UNITED STATES PATENT AND TRADEMARK OFFICE

APPLICATION NO.	FILING DATE	FIRST NAMED INVENTOR	ATTORNEY DOCKET NO.	CONFIRMATION NO.
10/750,854	01/05/2004	Shunpei Yamazaki	740756-2701	3727

Office Action Summary	Application No.	Applicant(s)	
	10/750,854	YAMAZAKI ET AL.	
	Examiner	Art Unit	
	W. David Coleman	2823

DETAILED ACTION***Claim Rejections - 35 USC § 103***

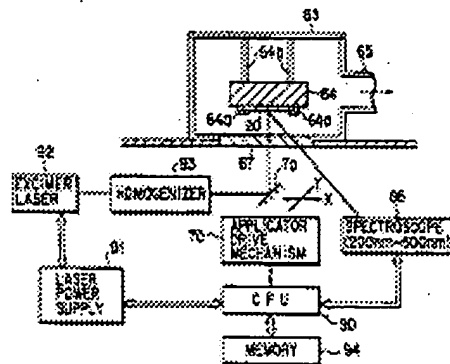
3. Littman discloses a method of manufacturing an electro-optical device substantially as claimed. See FIGS. 1-3e, where Littman discloses the following limitations.

providing a substrate **110** by a substrate holder (not shown, however, Littman discloses that the film formation is performed in a vacuum and therefore a substrate holder would be highly suggested) in film formation chamber (not shown);

forming a film comprising an organic material **130** over the substrate by vapor deposition in the film formation chamber wherein said organic material is simultaneously deposited on said substrate holder. Littman further discloses irradiating the organic material with a xenon flash lamp to cause the organic material to sublime (column 7, lines 41-55);

exhausting the sublimated vapor deposition material, wherein the vapor deposition material comprises an organic light emitting material. However, Littman fails to teach removing said substrate from said reaction chamber after forming said film;

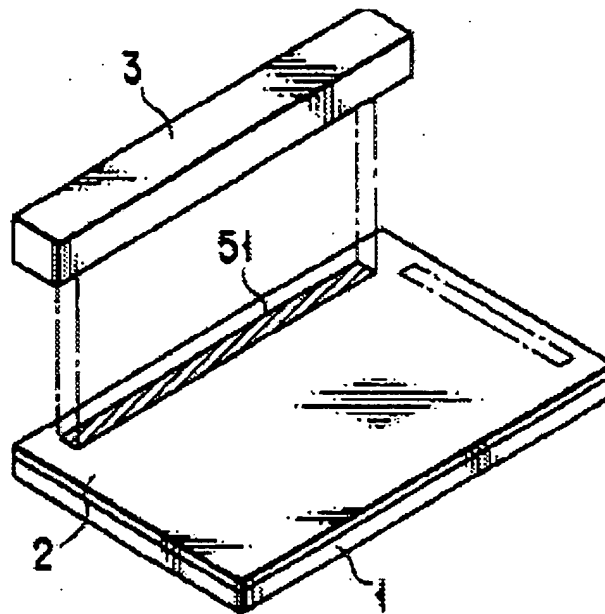
comprises an organic light emitting material. However, Littman fails to teach removing said substrate from said reaction chamber after forming said film;

Imahashi teaches removing said substrate from said reaction chamber after forming said film; irradiating a component provided in a film-forming chamber with a light selected from the group consisting of infrared light, UV-light, and visible light. See **FIGS. 1-20**, where Imahashi teaches a multi-cluster chamber. In view of Imahashi, it would have been obvious to one of ordinary skill in the art to incorporate the multi-cluster chamber into the Littman semiconductor process because a plurality of processes are performed on each substrate in a desired sequence (column 16, lines 19-20).

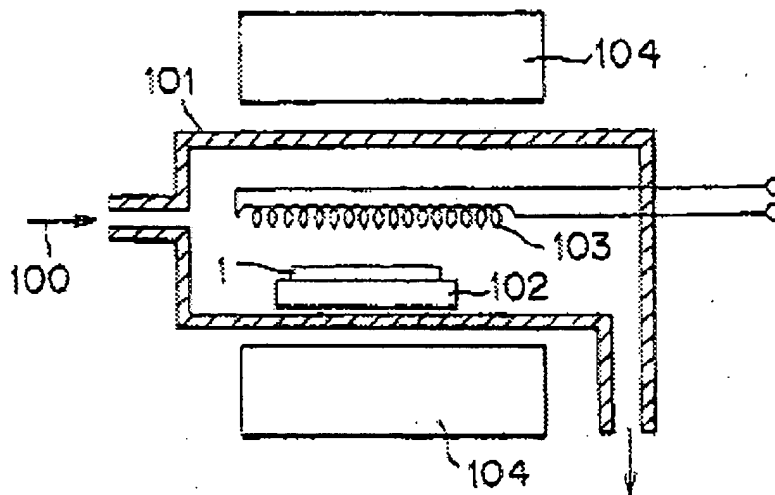
8. Pertaining to claims 30, 34 and 35, Littman in view of Imahashi teaches the method according to claims 27 and 28, wherein an irradiation surface of said light selected from the group consisting of the infrared light, UV-light, and visible light is in a rectangular or oblong shape (see **FIG. 18A** of Imahashi).

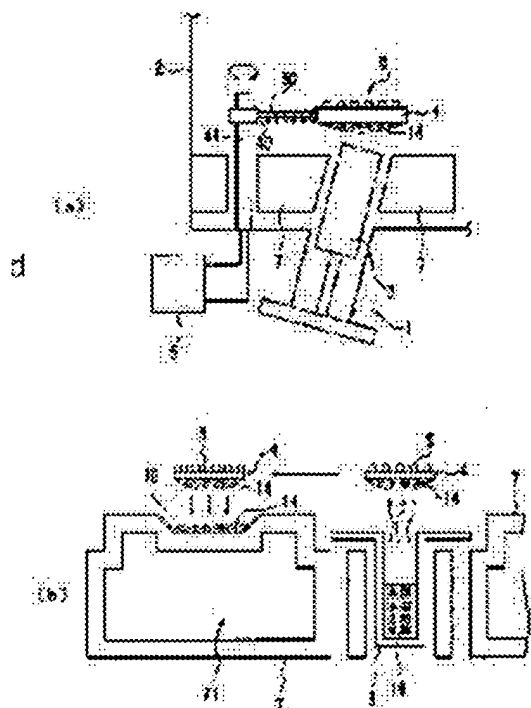
15. Nagashima discloses a semiconductor process substantially as claimed. See the drawings from the Japanese Patent Abstracts below.

16. Pertaining to claim 43, Nagashima teaches a method of manufacturing a display device comprising:

providing a substrate by a substrate holder in a film formation chamber wherein an adhesion preventing shield is provided between said substrate and an inner wall of the film formation chamber;

forming a film comprising an organic material over the substrate by vapor deposition in the film formation chamber wherein said organic material is simultaneously deposited on said adhesion preventing shield;

heating said adhesion preventing shield to vaporize said organic material deposited on said adhesion preventing shield;

exhausting the vaporized organic material from said film formation chamber. However,
